CITY OF JOPLIN
Main Street Streetscapes 8th St. to 15th St.

Addendum No. 1

ADDENDUM NO. 1

PROJECT:	Main Street Streetscapes – 8th ST to 15th ST Joplin, Missouri
BID OPENING:	10:00 A.M., May 21, 2026 602 S Main St. 4th Floor Joplin, Missouri

ISOLATION JOINT AT BUILDING

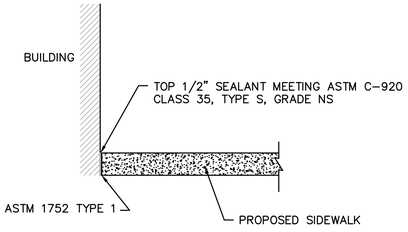
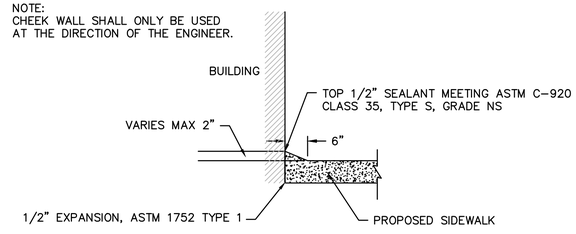
8. There are two separate details for expansion joint where the sidewalk meets the building face, one calls for ½" Expansion the other calls for ¾".
    a. The plans have been updated to reflect ½" expansion. This is typical of the other projects completed in the Main Street corridor.

SHEET
74 of 162

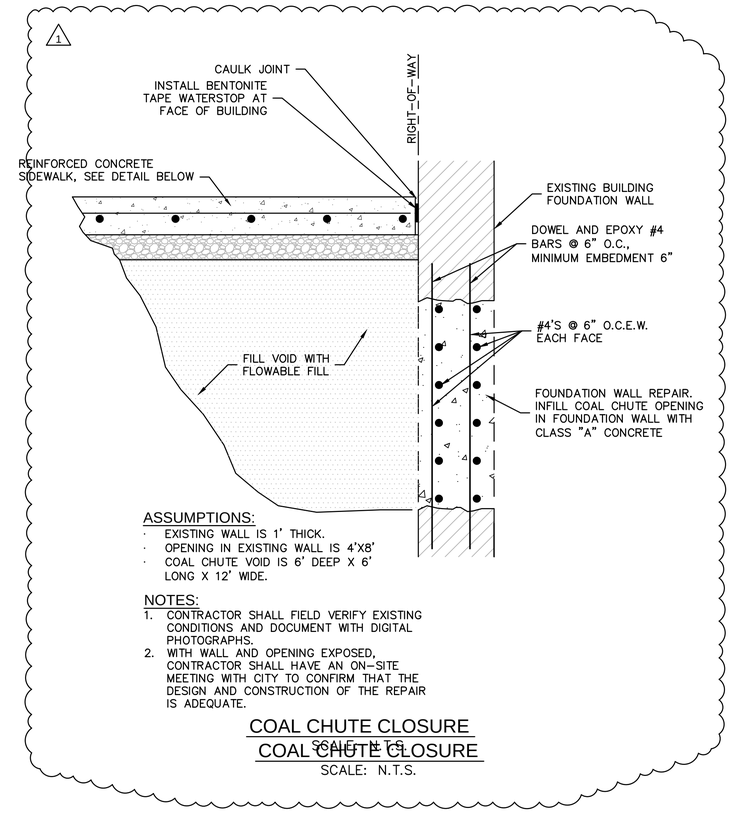
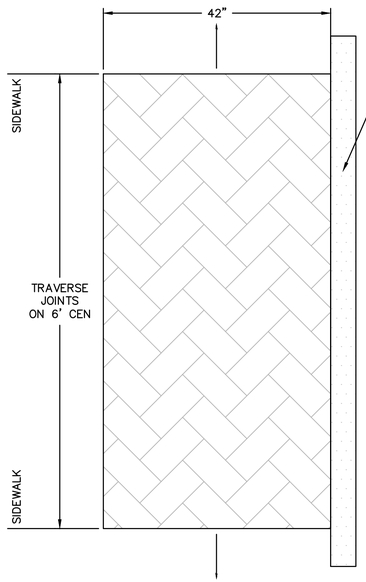
a. This item has been revised to a per EACH unit and a detail has been added to sheet 74.
4. A building at the Northwest Corner of 10th and Main Street is called out to be demolished. There is no LS pay item for Demo and there is no spec/requirements for the building demo. Are there permits required for this?

REV. NO.	DATE	REVISIONS DESCRIPTION	BY
1	5/13/2026	ADDENDUM #1 - COAL CHUTE CLOSURE DETAIL

SHEET
86 of 162

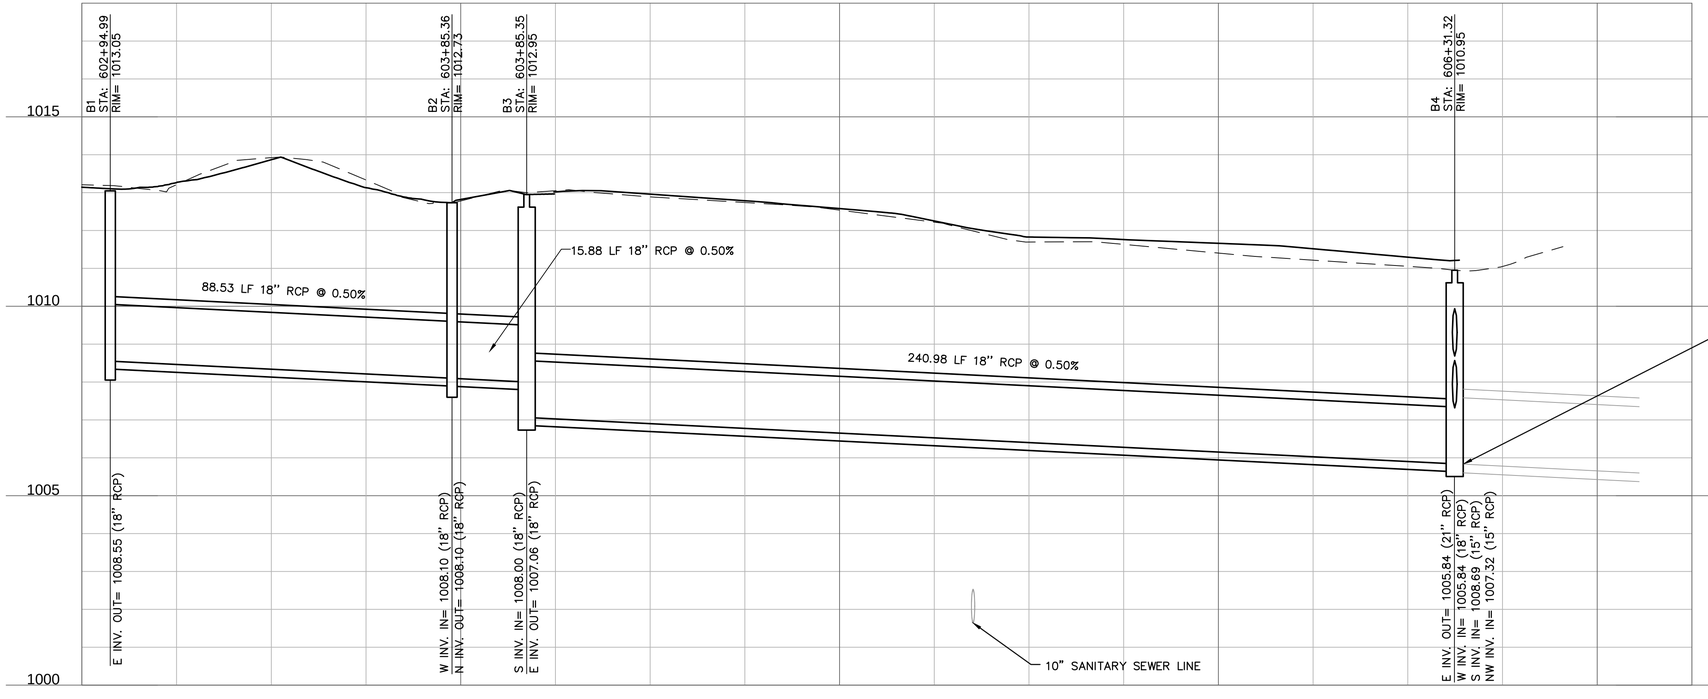
27. A Type E storm structure is called out on sheet 86, Joplin Standard Details do not include a Type E structure and no detail is included in the plan set. Please clarify this structure.

a. The structures on sheet 86 identified as Type E should be Joplin Standard Type A structures. The plan sheet has been revised.
28. "Special Decorative Planter" bid item questions
